Logos Apparels Ltd.-Unit-2

Observations

DEA Report required to be reviewed by Accord

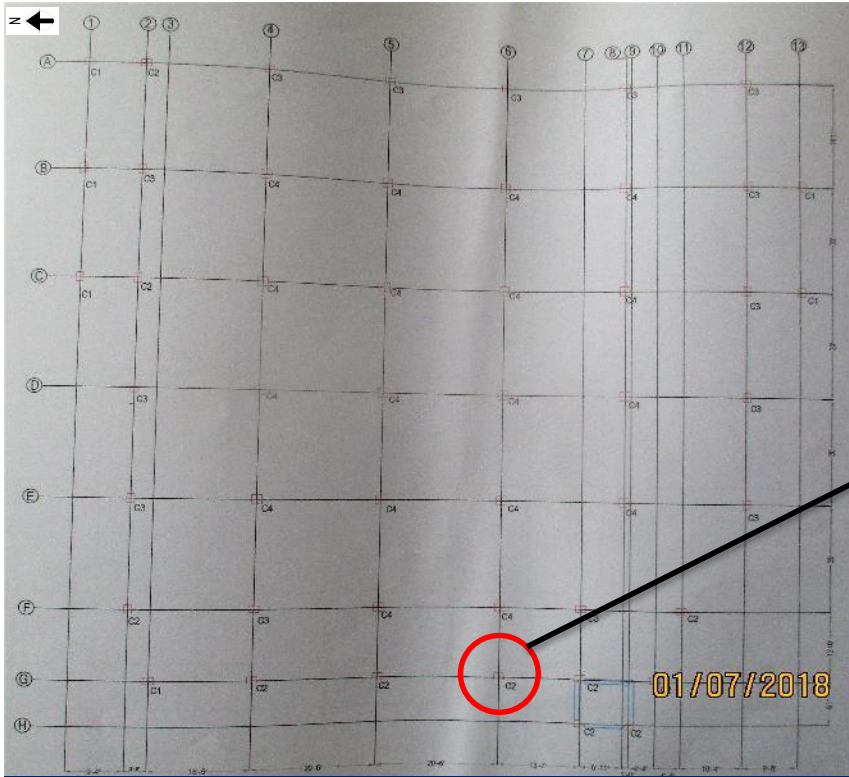
As per NTPA Guidelines (minimum live load 42 psf): From structural assessment it has been found that

All columns demand capacity ratio is lower than 1, Giving the retrofit properties in columns all columns demand capacity ratio becomes lower than 1. Therefore, columns not required any retrofiting.

Cursory calculation (considering 63 psf live load and core test report provided by the factory) indicates that highlighted columns appear to be stressed above normal design limits due to overhead water tank and brick wall & build-up of toilet area. Whereas all columns were declared as safe for carrying 42 psf live load in the conclusion of the provided DEA report. Factory is required to revise the DEA report according to BNBC provision and submit to ACCORD for further review.

Column layout

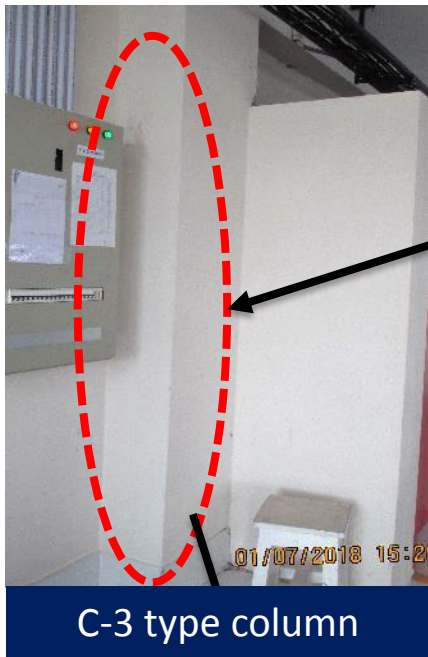
Mixture of stone & brick aggregate was found in the marked column

Combination of stone aggregate & brick aggregate was found in the above marked column. Factory is require to verify the concrete strength of the marked column and incorporate it in the DEA report.

Column Layout Plan

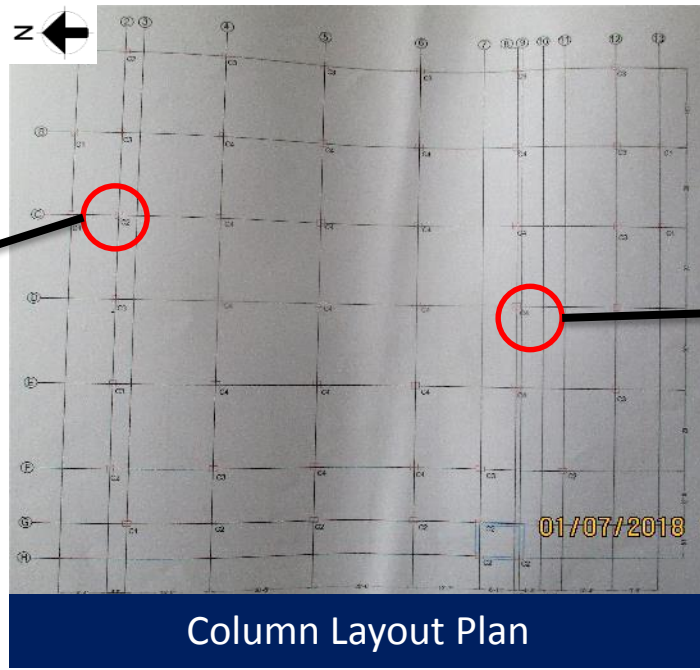
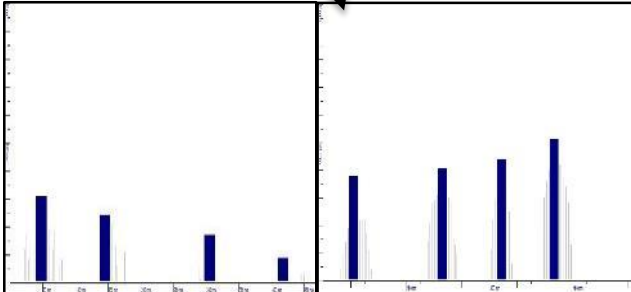
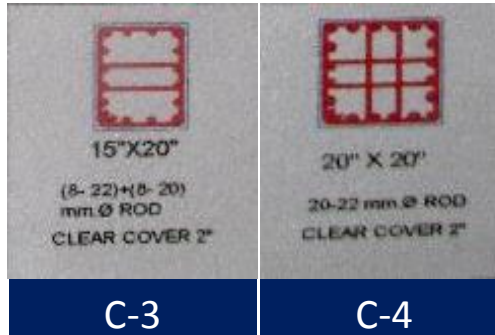
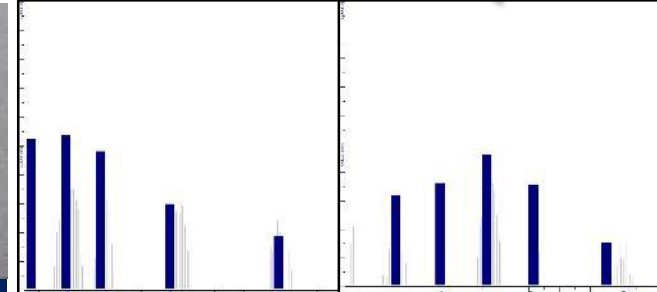
12 nos. rebar found by ferro scanning in C-3 type columns instead of 16 nos.

16 nos. rebar found by ferro scanning in C-4 type columns instead of 20 nos.

Number of rebars in C-3 & C-4 type columns were found less than that of shown in column schedule of as-built structural drawing.

Factory is required to update the as-built drawing which reflect the actual condition.

Beam Layout Plan

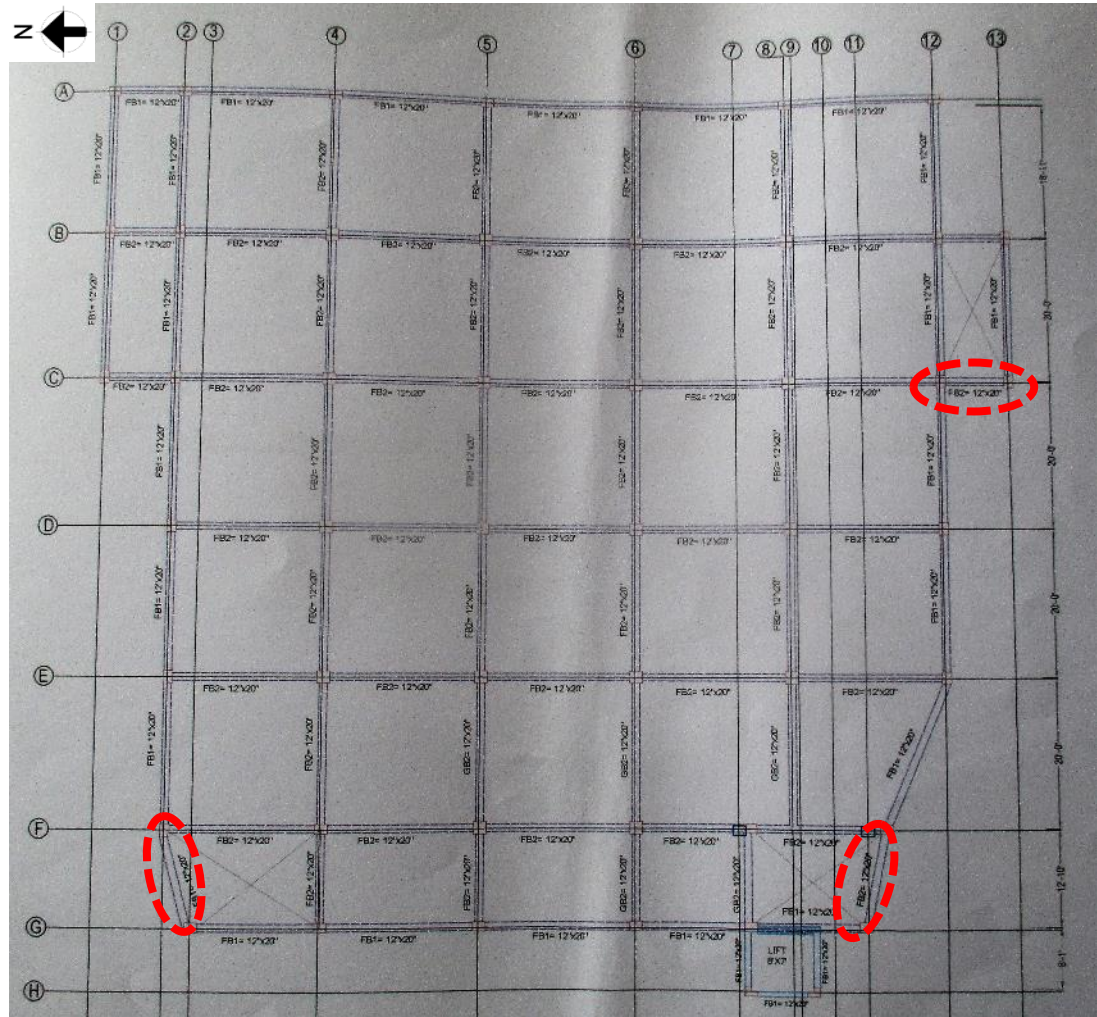
No floor beam was found at stair case on marked location.

Three beams were not found at the marked location on each floor. Whereas, floor beams were shown in provided as-built drawing.

Slab layout Plan

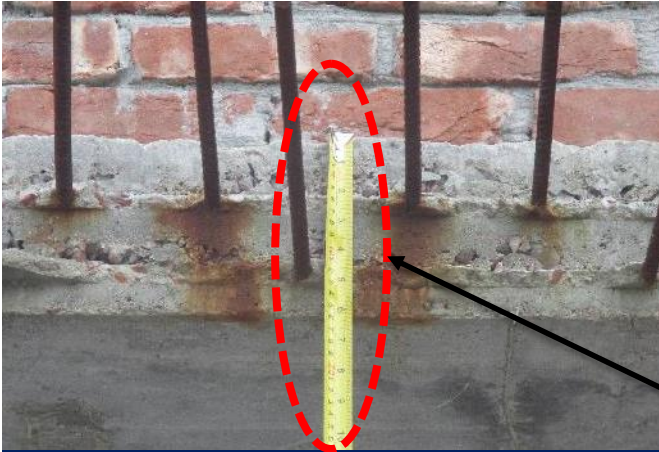
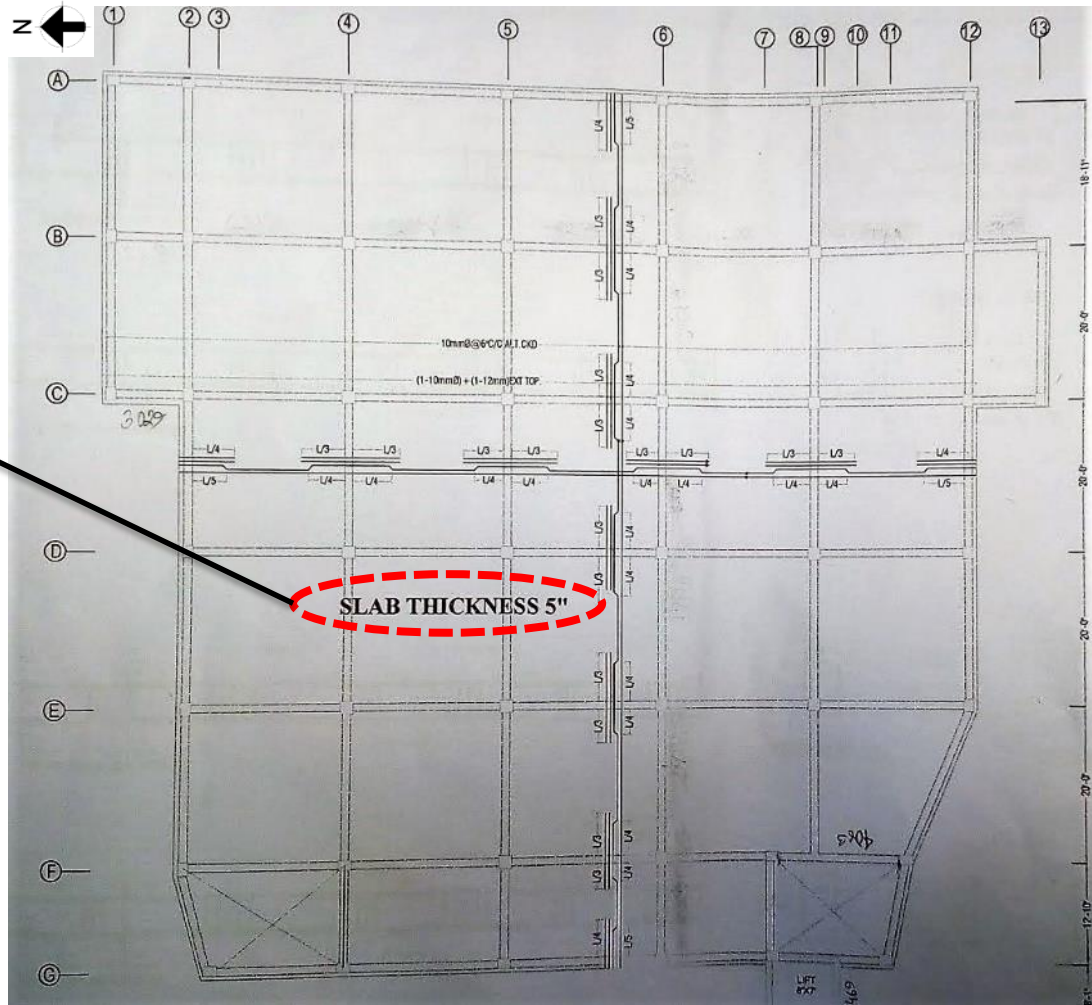
Slab thickness was found 6 inches on site

In provided drawing, slab thickness was shown as 5 inches. Whereas, slab thickness was found 6 inches on site.
